ADDENDUM 2

CSP 22-68

Memorial Middle School Heating & Air Condition (HVAC) Improvements Funded through the Elementary & Secondary Emergency Relief (ESSER) Funds

April 8, 2022

DATE:	4/7/2022
DRAWN BY:	DBR
CHECKED BY:	DBR
PROJECT NUMBER:	218007.002
SHEET TITLE:	MECHANICAL CONTROLS
SHEET NUMBER:	M4.02

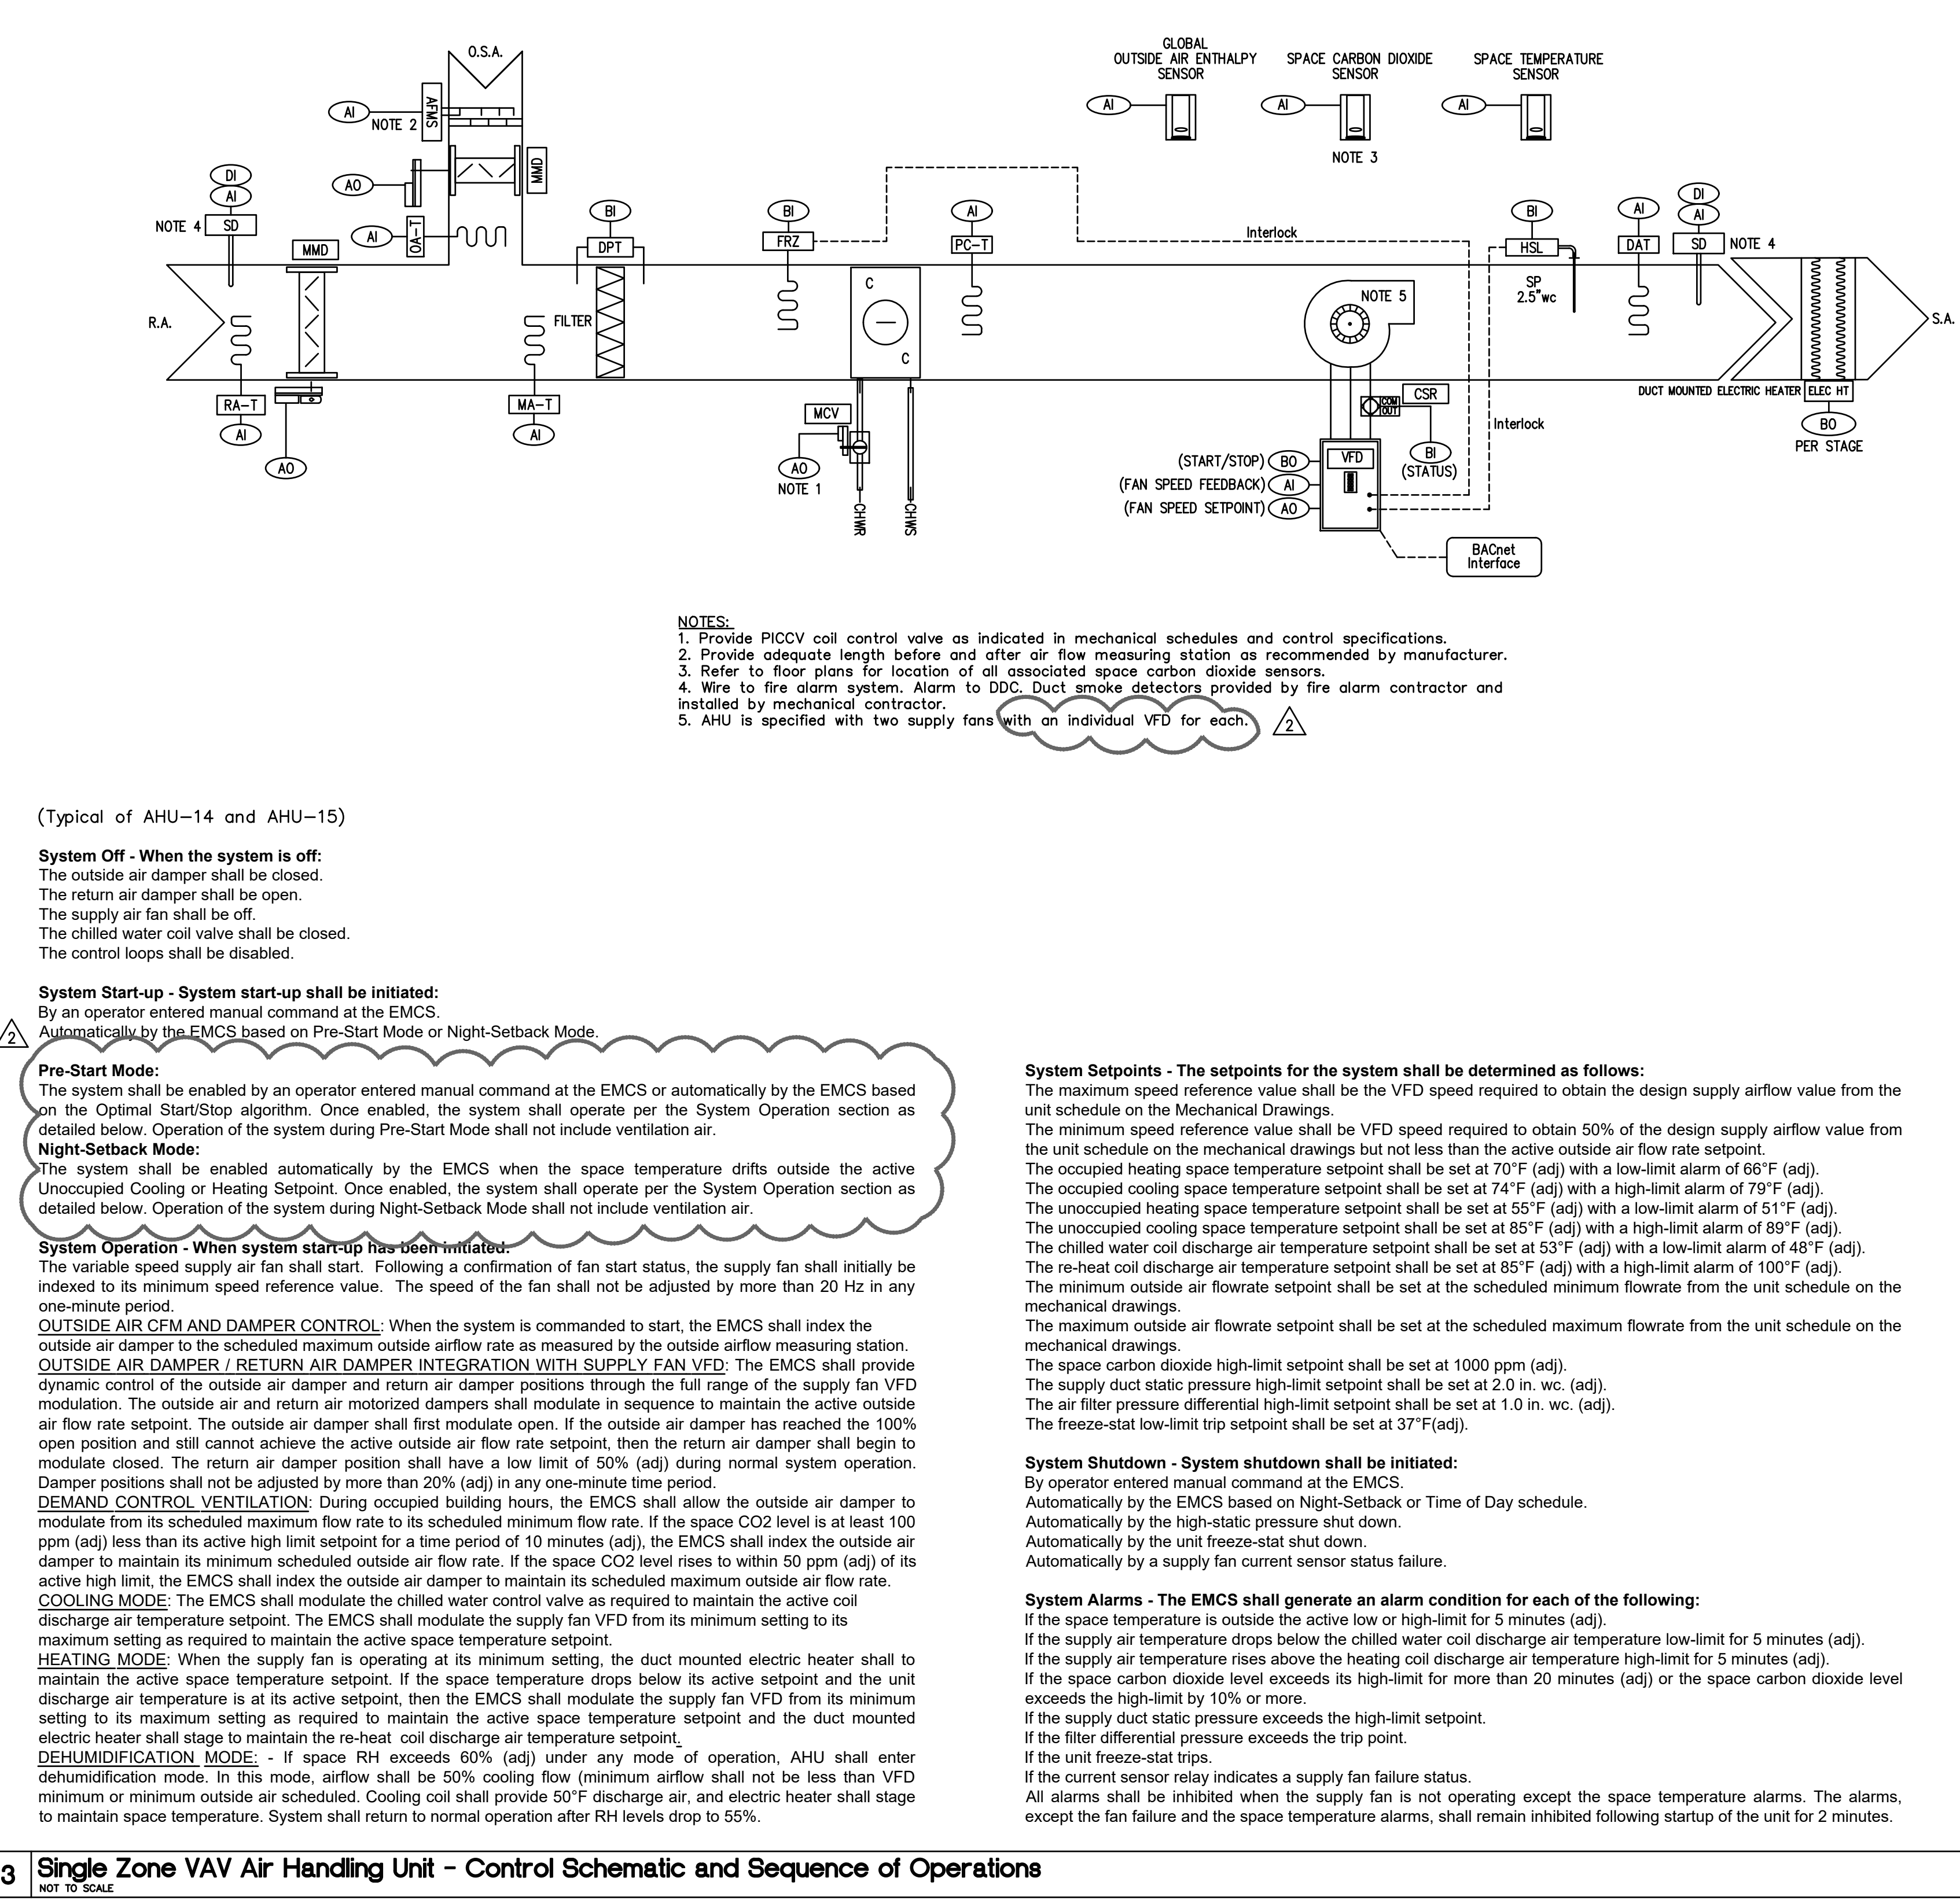
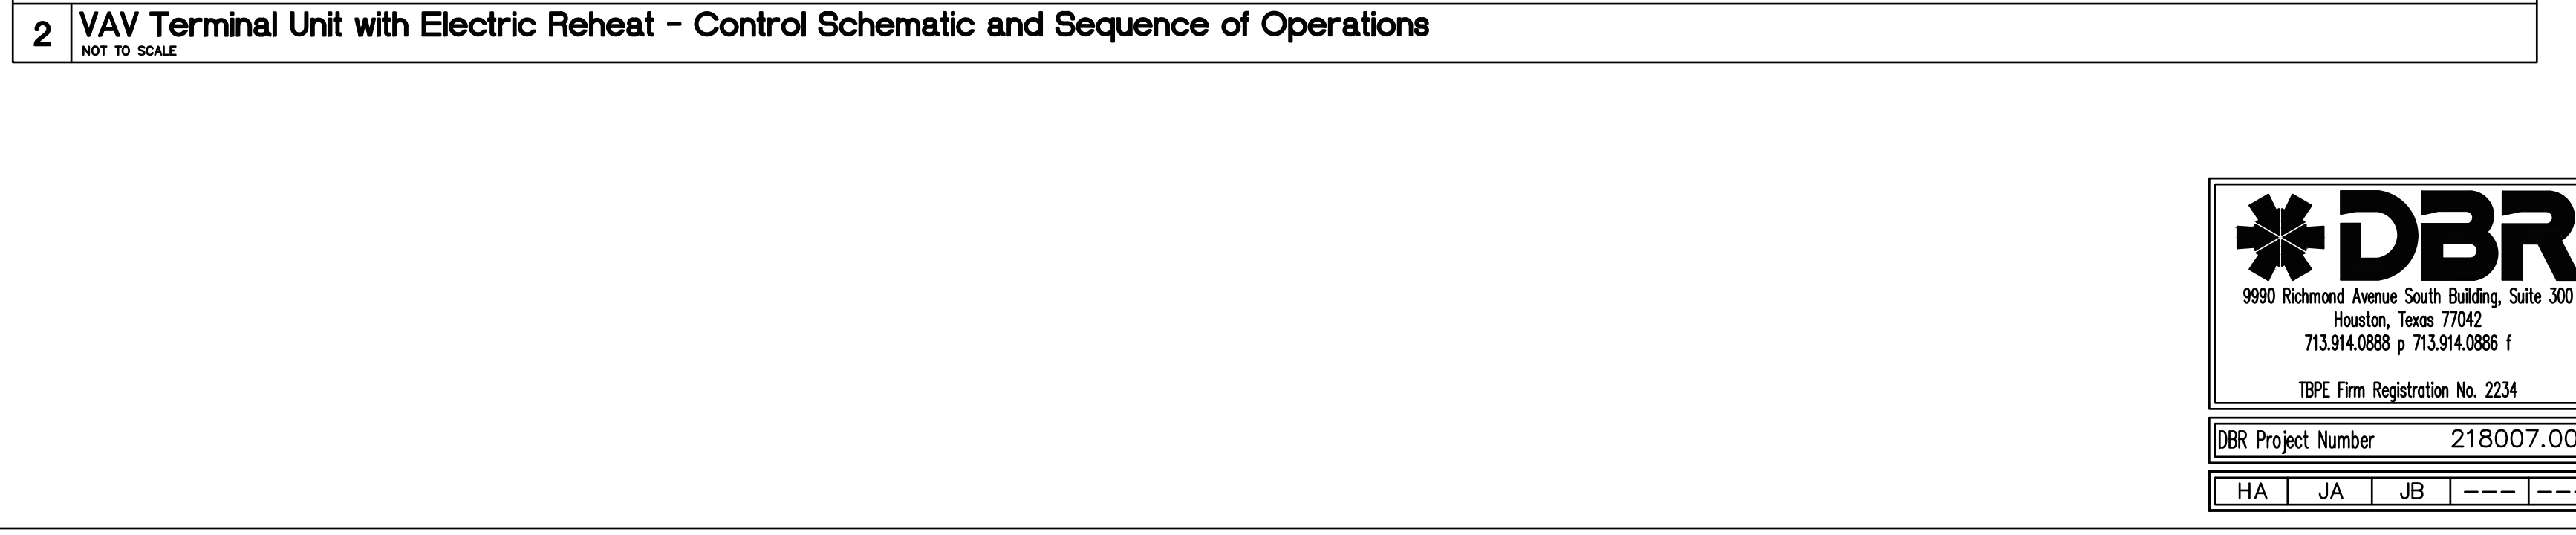
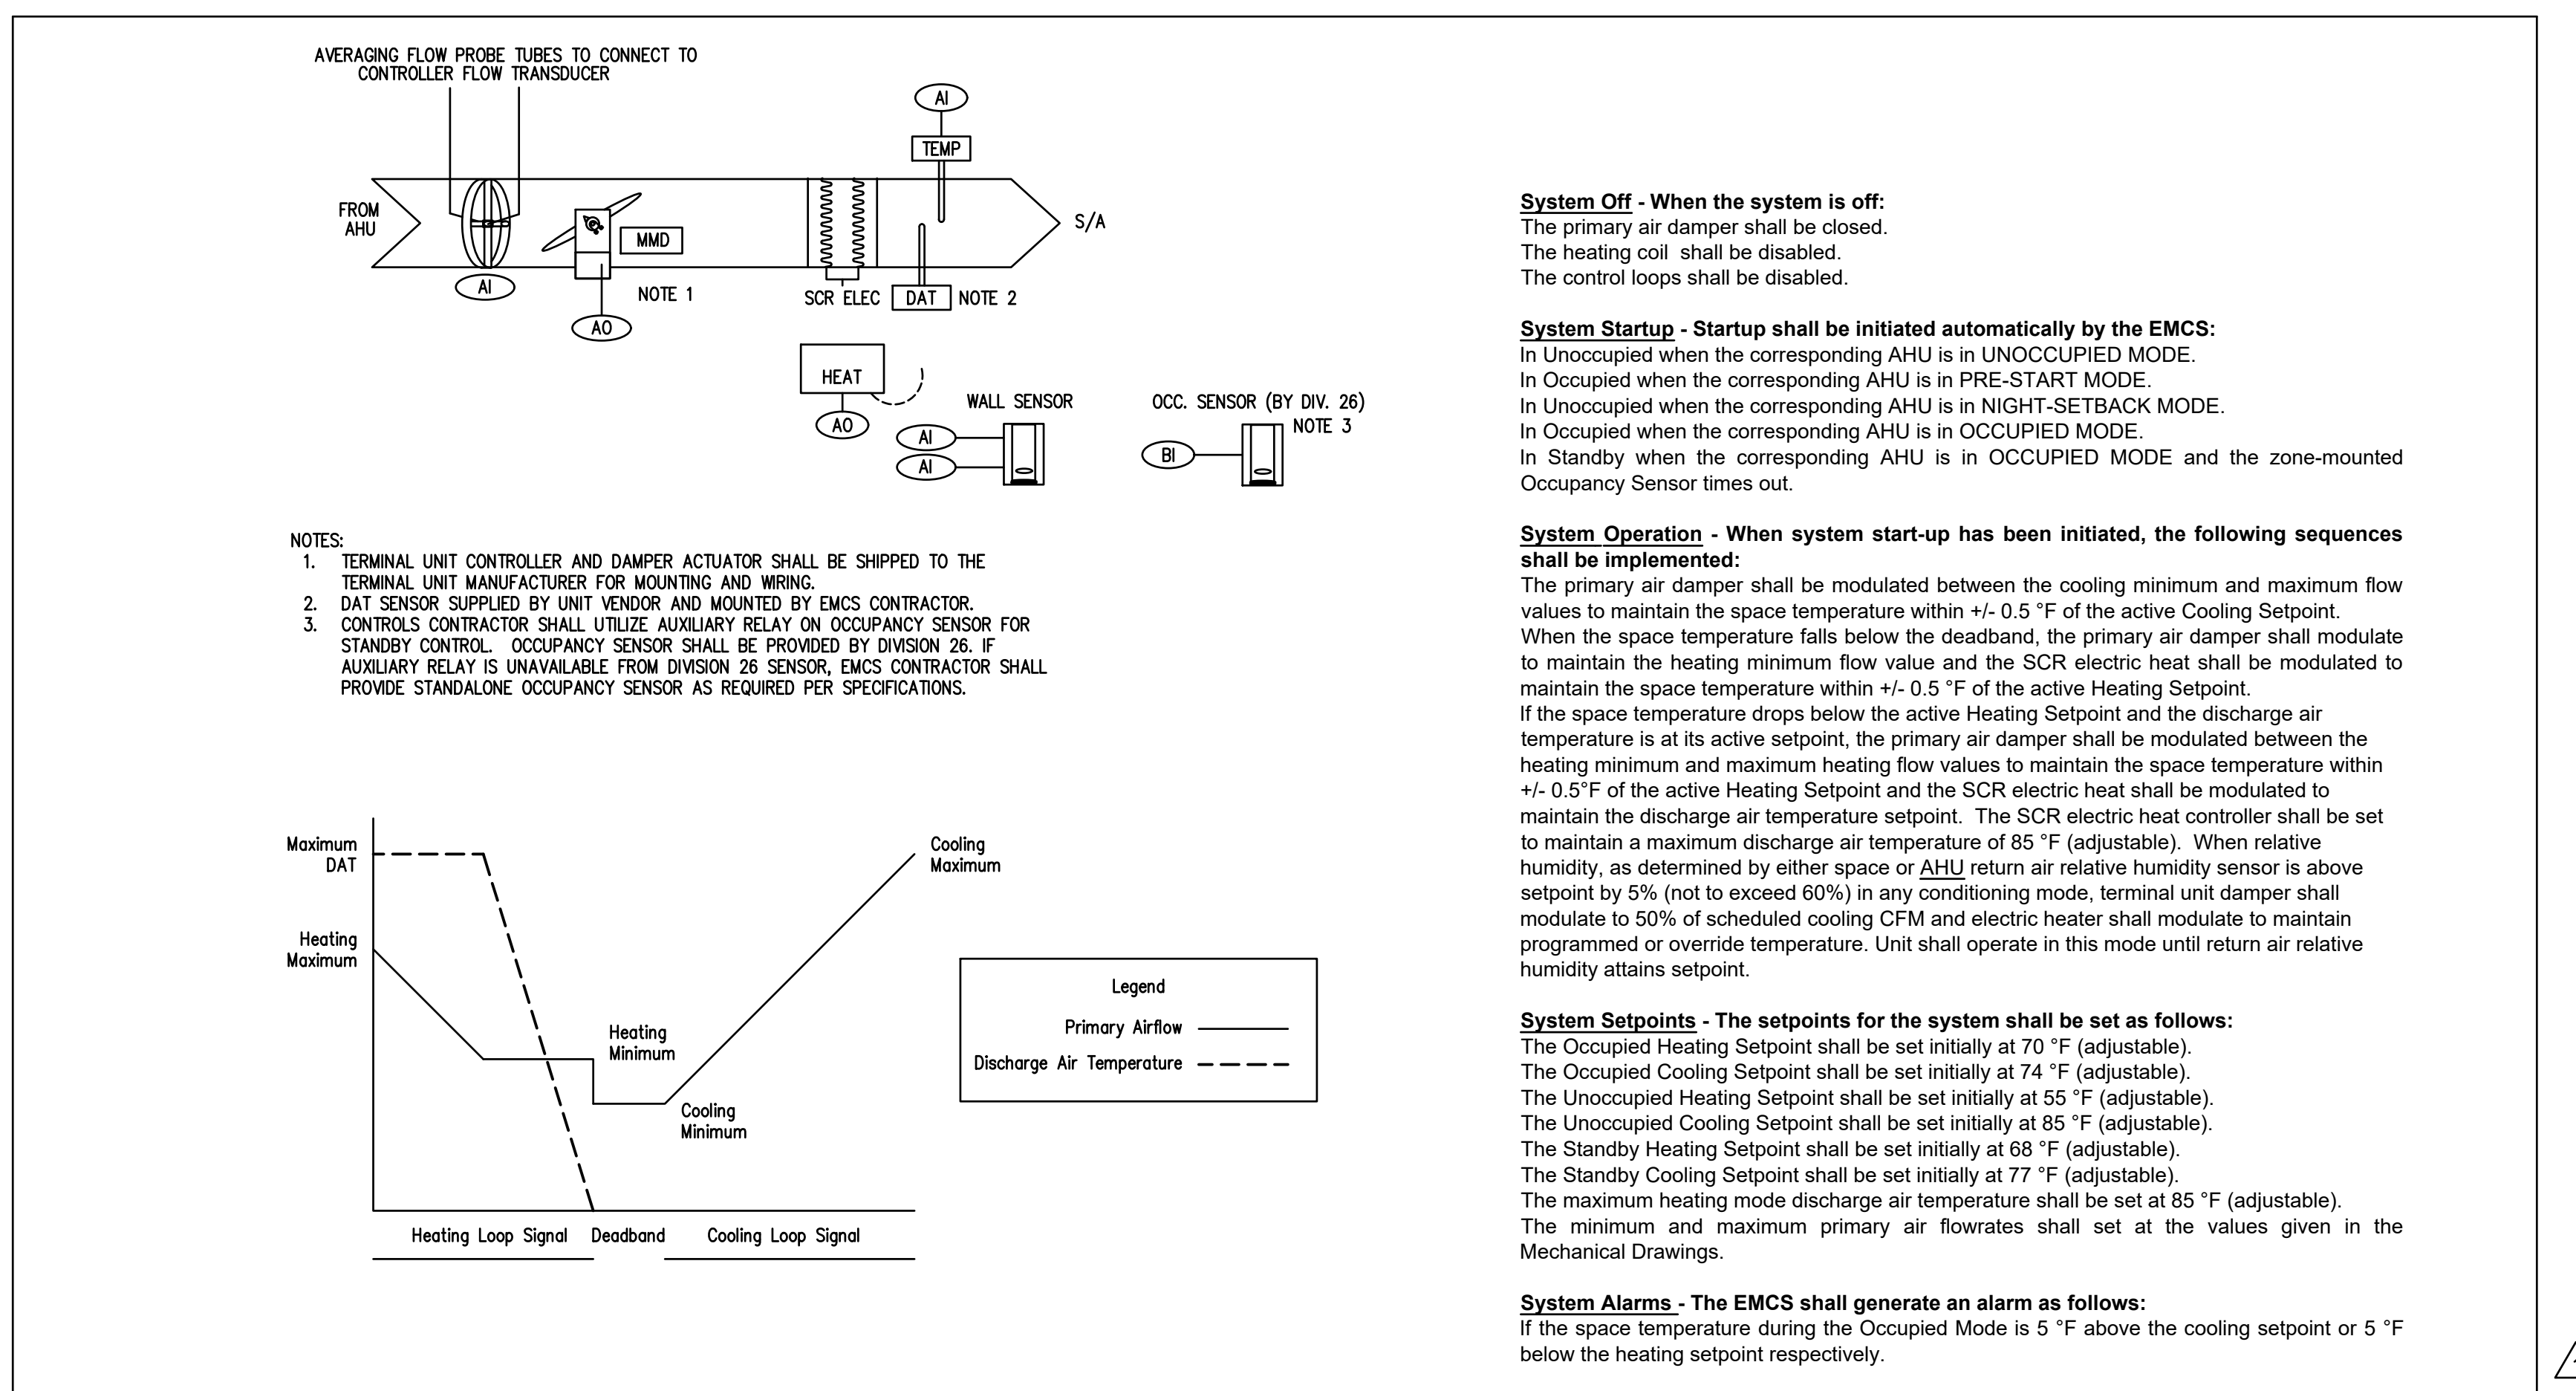
Item 15 SHEET M4.02 – MECHANICAL CONTROLS

A. Revised Single Zone VAV Air Handling Unit – Control Schematic and Sequence of Operations.
B. Revised Multi Zone VAV Air Handling Unit – Control Schematic and Sequence of Operations.
